LiDAR Quality Assessment Report

Materials Received: 3/2/2012	Project Type: Donated Data
Project ID: UT_Lowry-Water_2011	Project Description: Pilot Data for UT_Lowry-Water_2011
Project Alias(es): Lowry	Year of Collection: 2011

UT_Lowry-Water_2011_Pilot

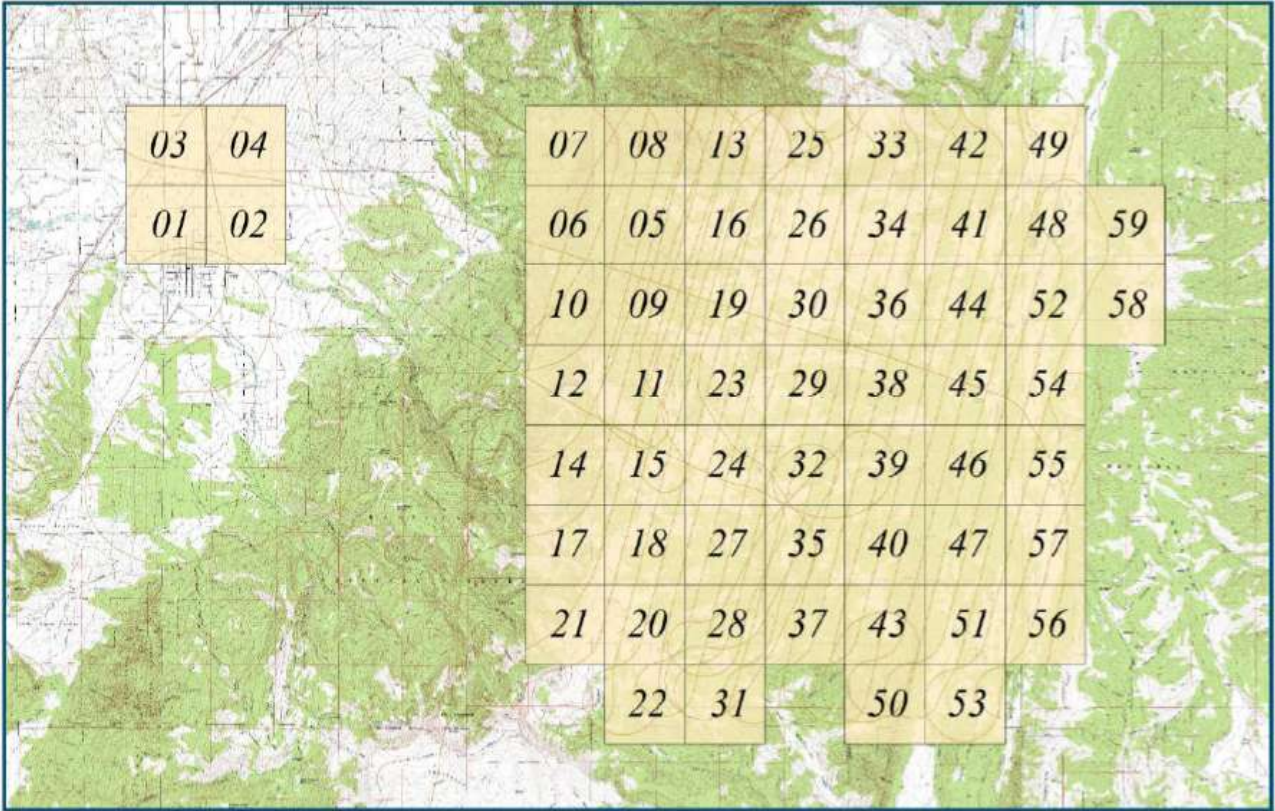
Based on this review, the USGS does not recommend the bare-earth DEM files for inclusion in the 1/3 Arc-Second National Elevation Dataset.

Based on this review, the USGS does not accept at this time the bare-earth DEM files.

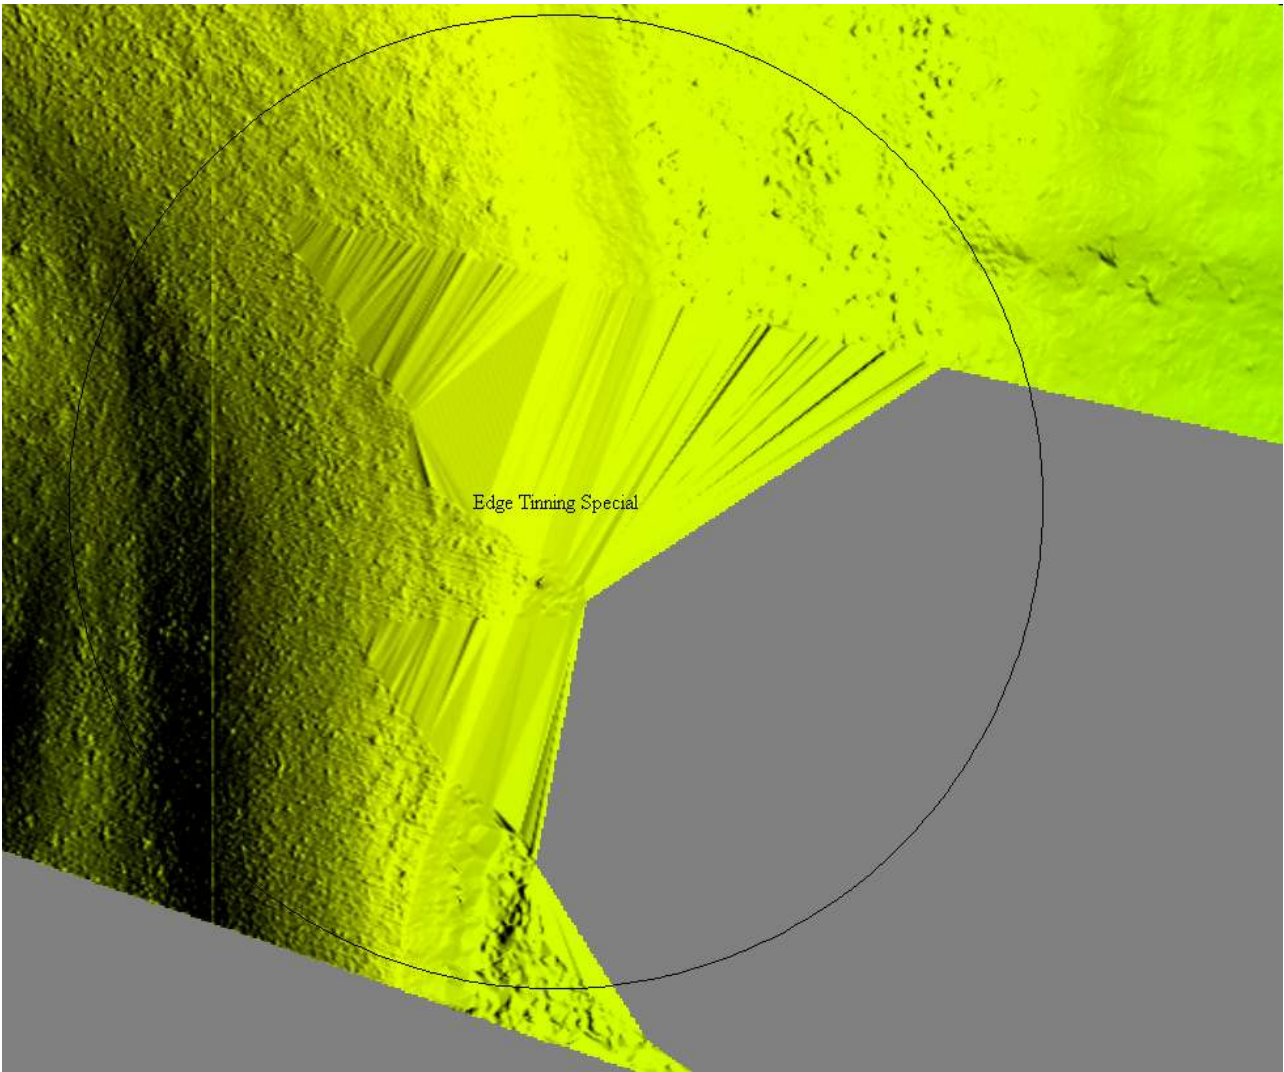
DEM Tiles are in ArcINFO ASCII Format. 32 bit floating point Erdas Imagine IMG followed by Binary ARC GRID is the USGS Preferred format(s).

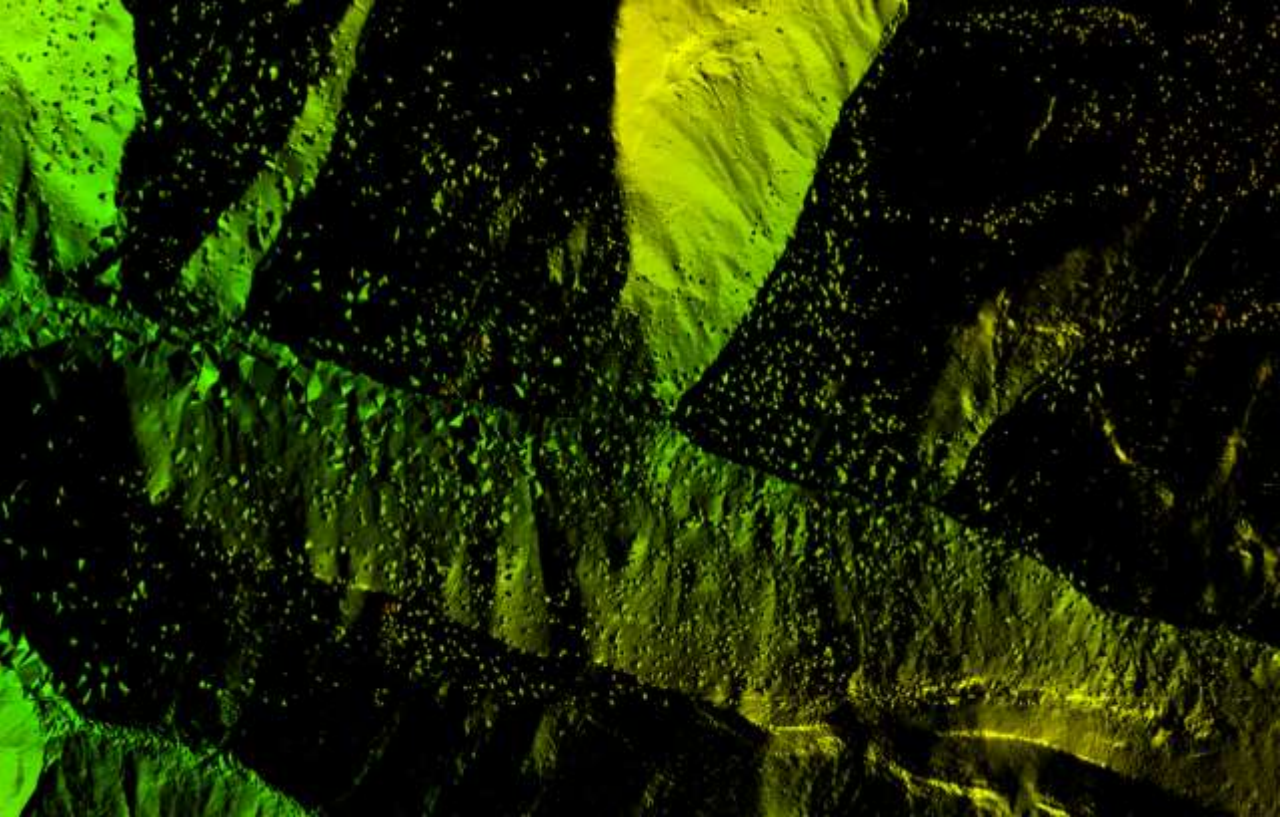
Tinning Edges Evident around concave edges of DEM tile's. These can be removed when mosaicing or by cropping with the use of a project boundary polygon. The provided project boundary polygon will remove some of these edge tinning artifacts, but not all as the boundary does not properly eliminate all areas. Areas that should be fixable are denoted as "Edge Tinning", while other areas are marked as "Edge Tinning Special" in the DEM error Tags Shapefile. USGS generated a new project boundary from the classified point cloud using only the Bare Earth points as input. This file, "Classified_Boundary.shp", is provided in the USGS Report Folder and can be used to crop out most of these tinning effects in the data, though some Tinned areas are still within the boundary; for this reason, A best practice is to fly the Lidar with a buffer in excess what the DEM's will ultimately be clipped to, making it east to delineate an interior project boundary that will likely have adequate point coverage.

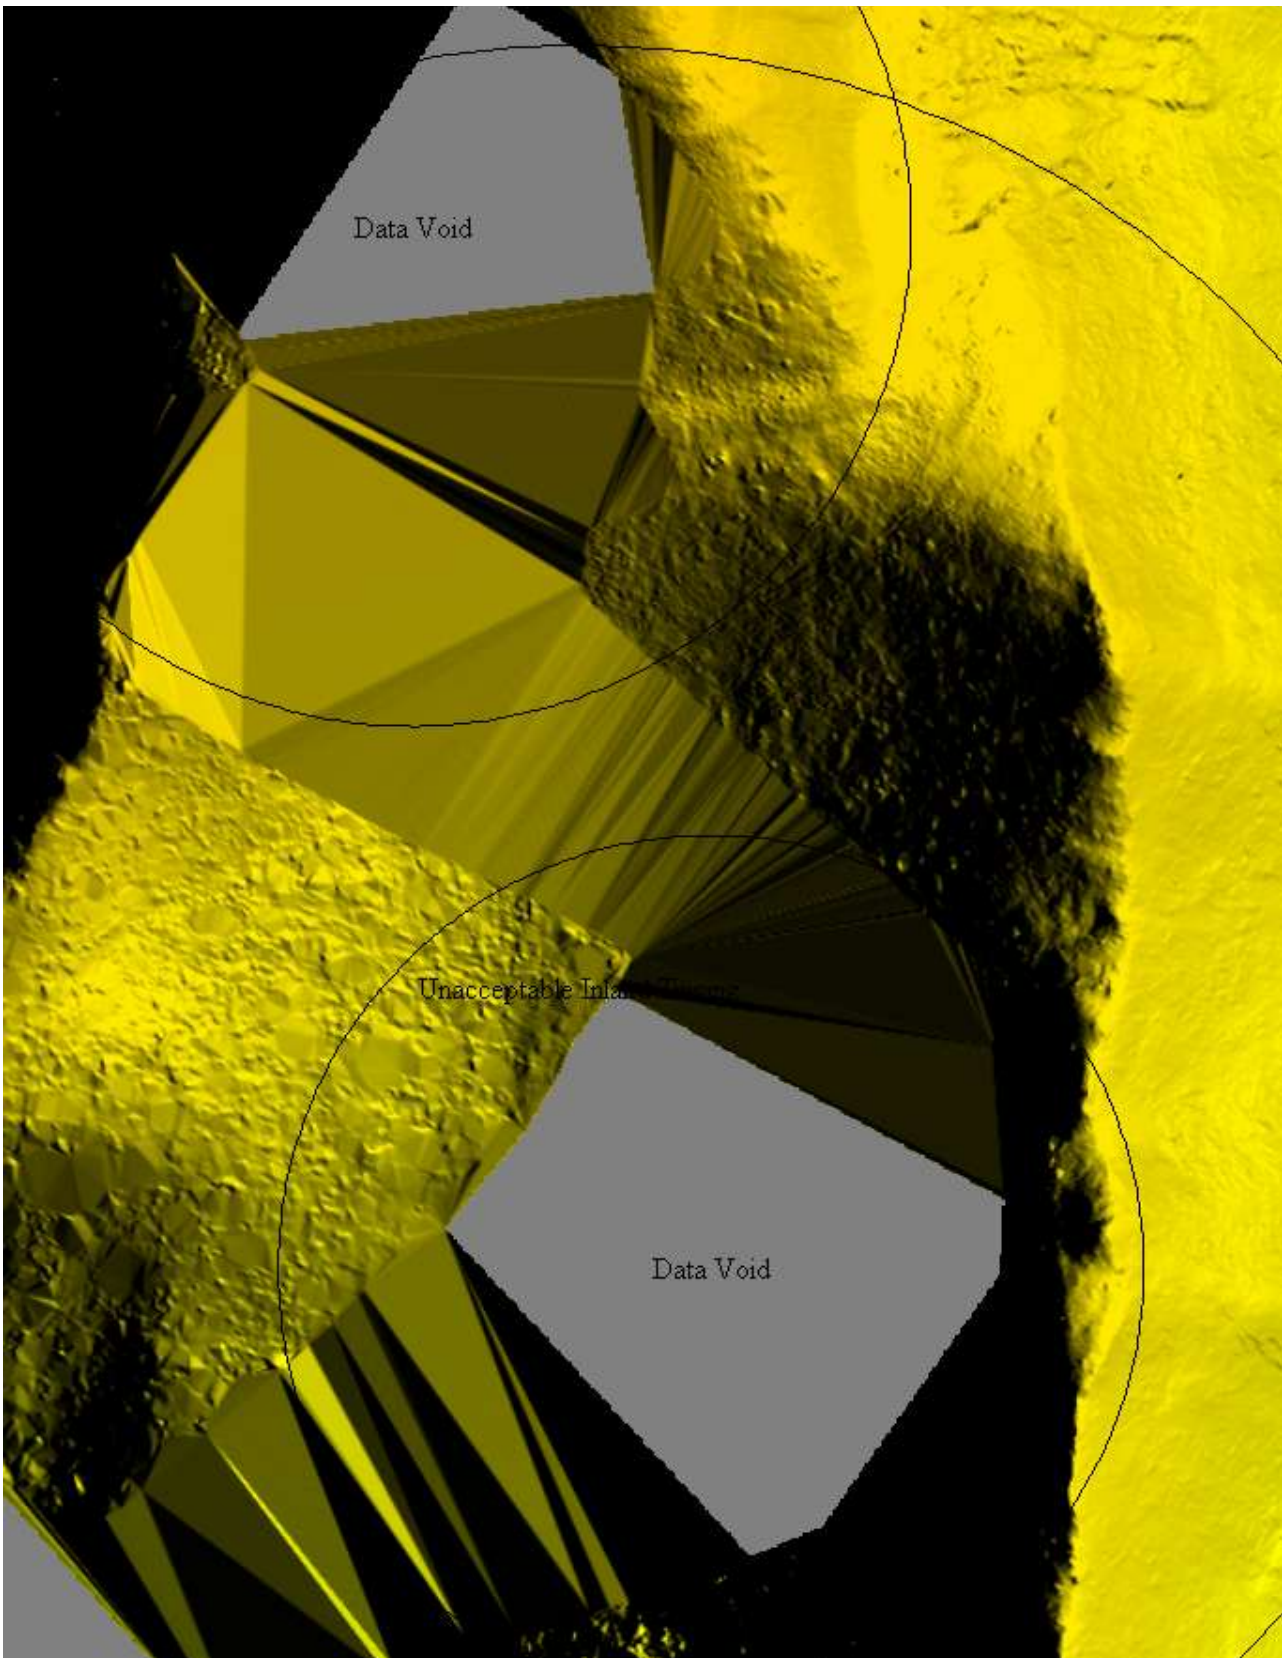
Too Much "Noise" in parts of the DEM, suggesting classification of bare earth in the point cloud was not rigorous enough, chiefly in the North West portion of the dataset. Some of the noise is grossly high. Such errors have been tagged Noise in the DEM error tags shapefile. This issue ABSOUTLY MUST BE FIXED OR THE DEMs WILL NOT BE ACCEPTED. See JPEG screen captures for more depictions of this "noise" problem.

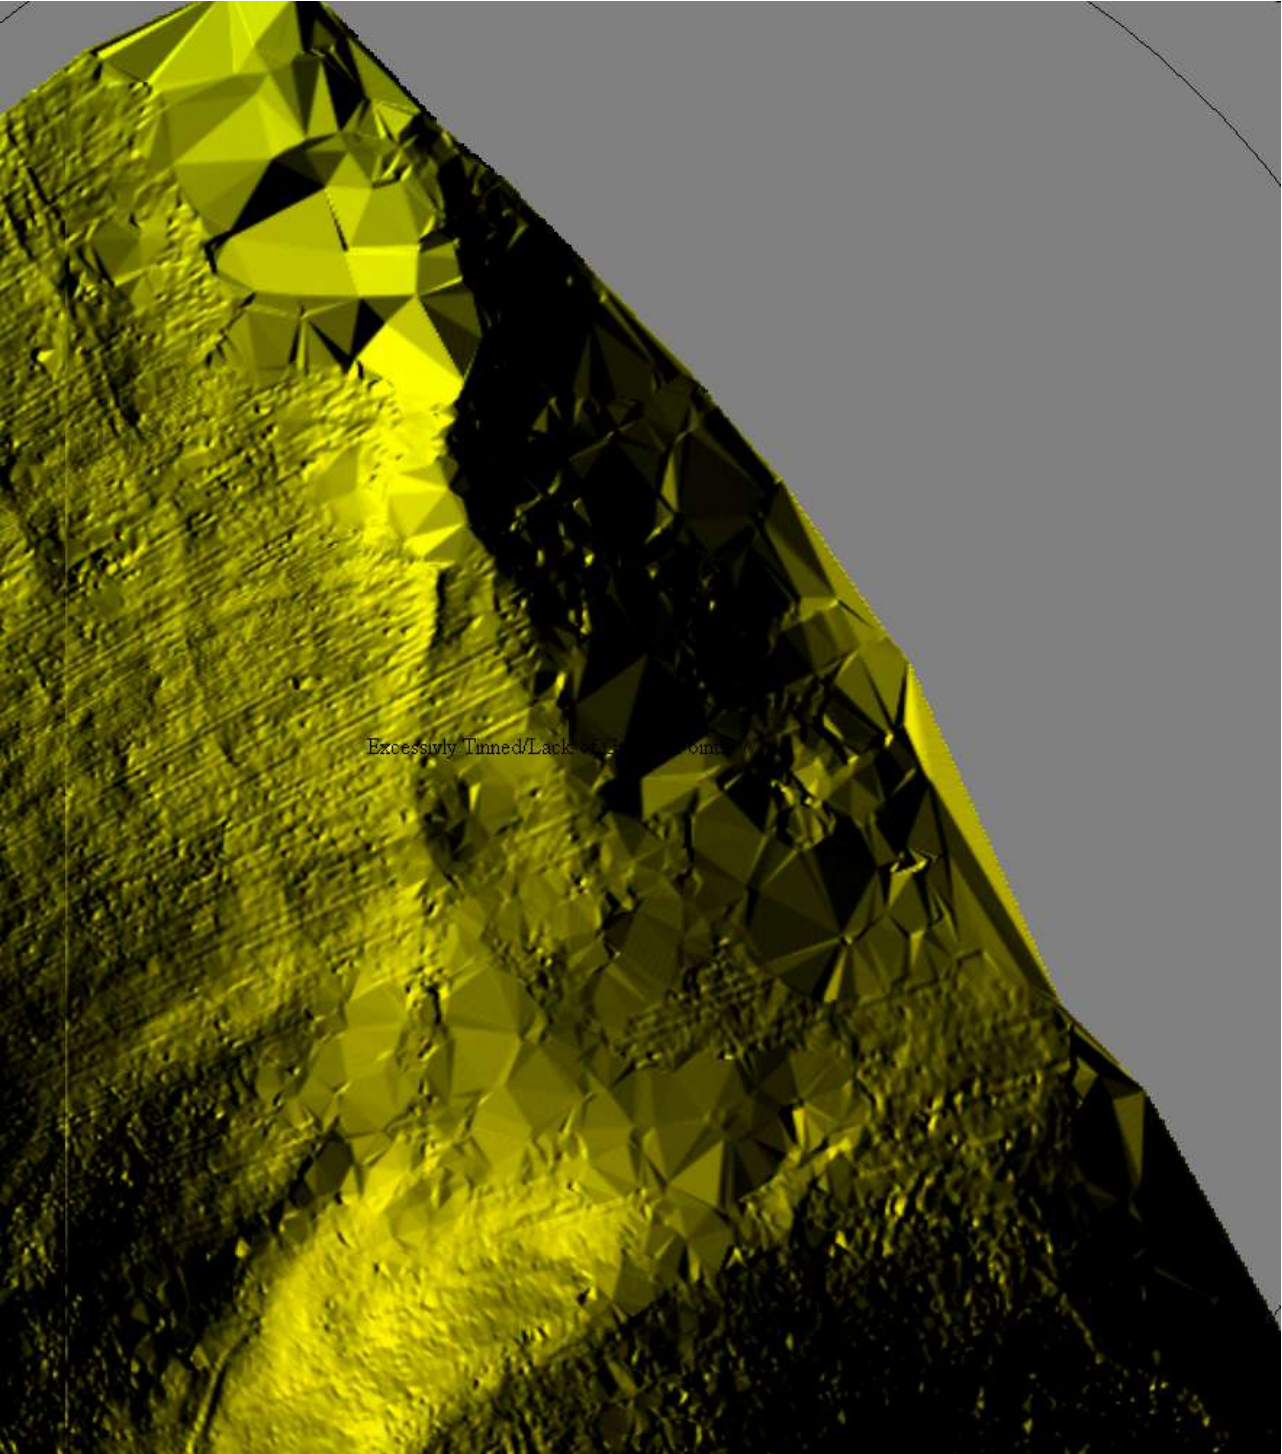
Two Large Data Voids were Located. These appear due to Tinning where no point coverage was available. Clipping or mosaicing with appropriate project boundary would likely correct the issue. The Tinning surrounding the Data Voids is also not acceptable.

Unacceptable Inland Tinning, examination of point cloud suggest the point density is low in this area.
